66101A-09

S E R V I C E N O T E

66101A DC Power Supply

The instrument will not communicate or will not complete self test.

Figure1

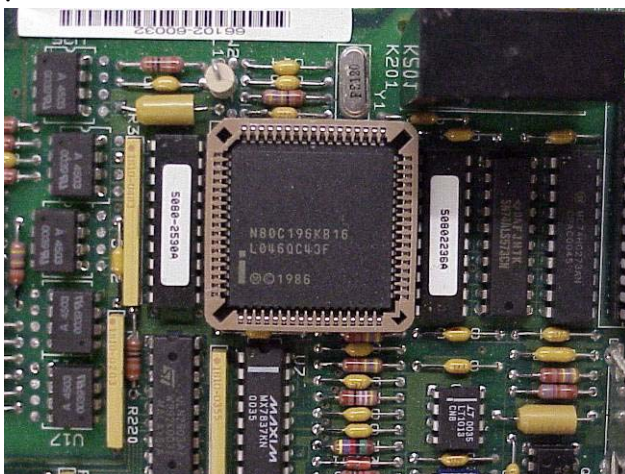
Figure 1 will help to identify the **68-PIN PLCC SOCKET location** - P/N 1200-1274 (Circuit Reference “U001”)

Figure 2

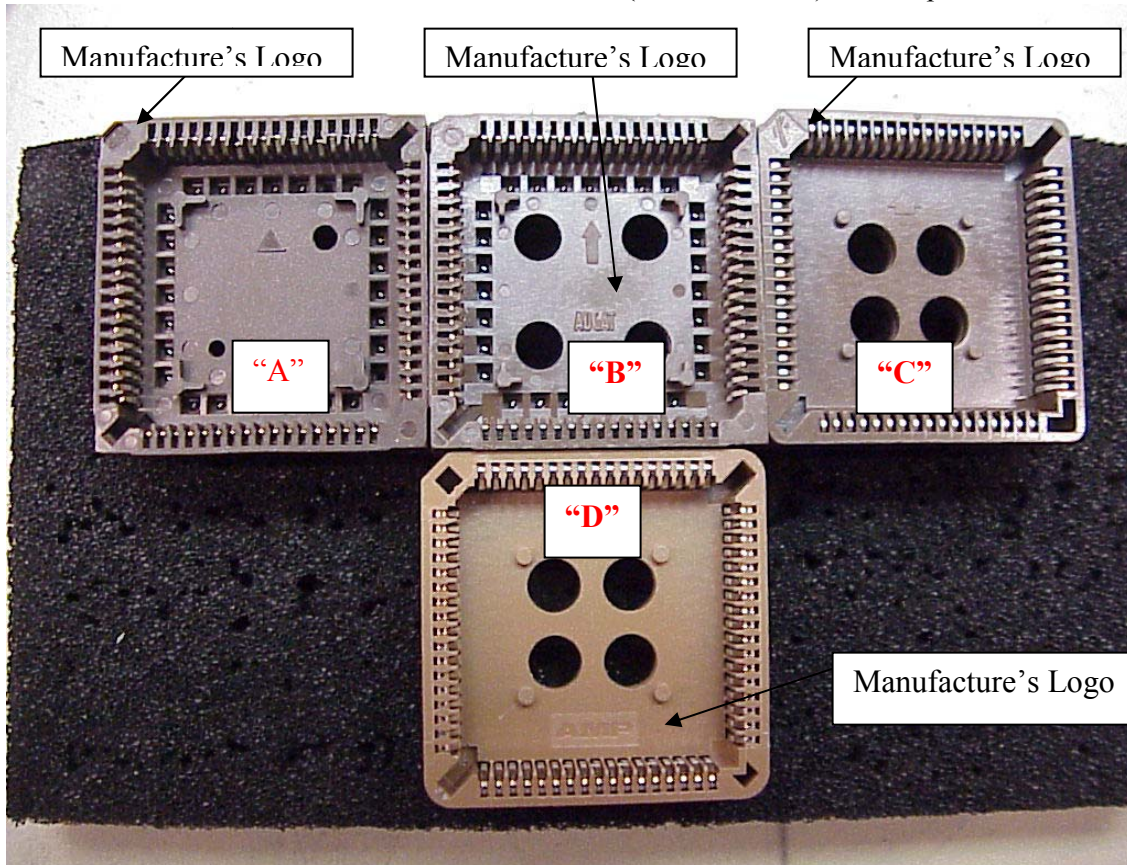
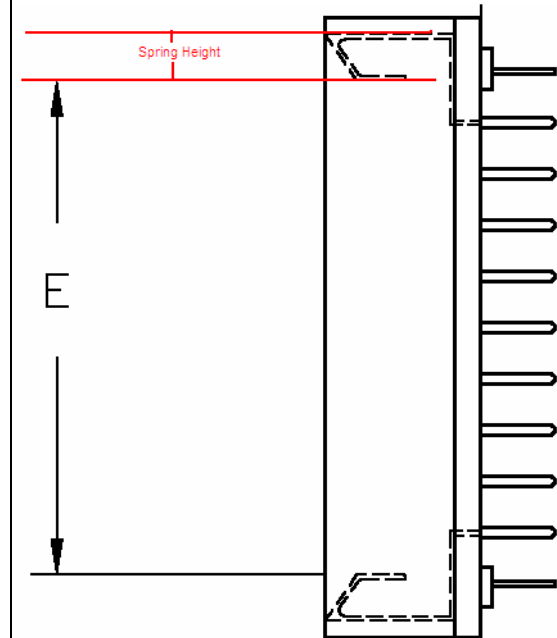
This figure should be used to identify **GOOD** sockets and a potential defective socket. The **16-Bit MCU 16 MHZ 68PLCC CMOS IC** (P/N 1821-1479) is **NOT** pictured.

The following information will help identify each socket type and manufacturer. The manufacturer's logo can be identified as shown. After the **16-Bit MCU 16 MHZ 68PLCC CMOS IC** has been removed there are also mold markings that can be easily viewed these markings should be used to identify a **Good or Defective socket**.

- Socket **"A"** is a sample of a GOOD AMP socket.
- Socket **"B"** is a sample of a GOOD Tyco/Augit socket.
- Socket **"C"** is a sample of a GOOD FCI socket.
- Socket **"D"** is a sample of a DEFECTIVE Tyco socket.

The sockets above labeled **"A", "B" or "C"** are good and should NOT be replaced.
The socket above labeled **"D"** is considered defective should be replaced.

Discipline B – Verification of Corrective Action “The socket shown in the pictures are for reference ONLY”

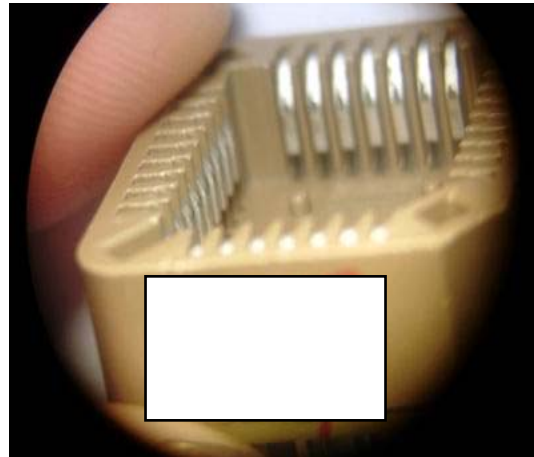
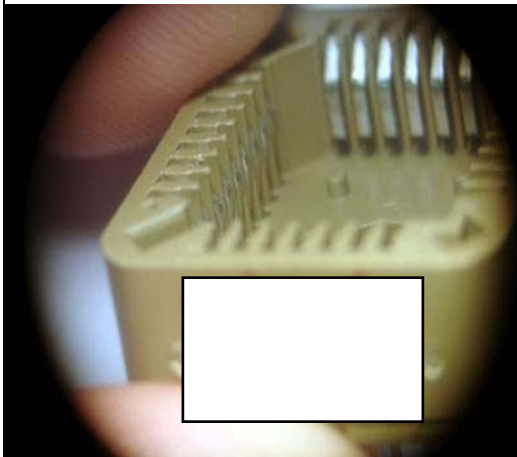
The condition of the recessed beams has been corrected by a design enhancement implemented in production. This design enhancement increased the spring height dimension by 0.04mm and decreased the spring height tolerance by 40%. The spring height dimension is shown in the drawing below.

This design enhancement is intended to position the contact beams closer to the middle of the socket and increase the normal force exerted on the contacts of the chips mated to the socket.

The effectiveness of this design enhancement was tested by comparing the mating and un-mating forces on the older and newer designs. The test results for sockets with the increased spring height (newer design) showed an increase in the mean mating force of 18.9% and an increase in the mean un-mating force of 23.4%. The increase in the un-mating force test results between the old design and the new design indicate that a greater normal force is being exerted on the test chip contacts by the socket contact beams. The two revisions of this contact beam design were visually examined after the mating and un-mating force testing. Photos of the two sockets are shown below. The photo on the left shows the older version socket prior to the enhanced contact beam design. The photo on the right shows a socket with the design enhancement. The contacts with the older design appear to be recessed farther into the housing after un-mating.

Material with this design enhancement will be labeled with a 2007 date code
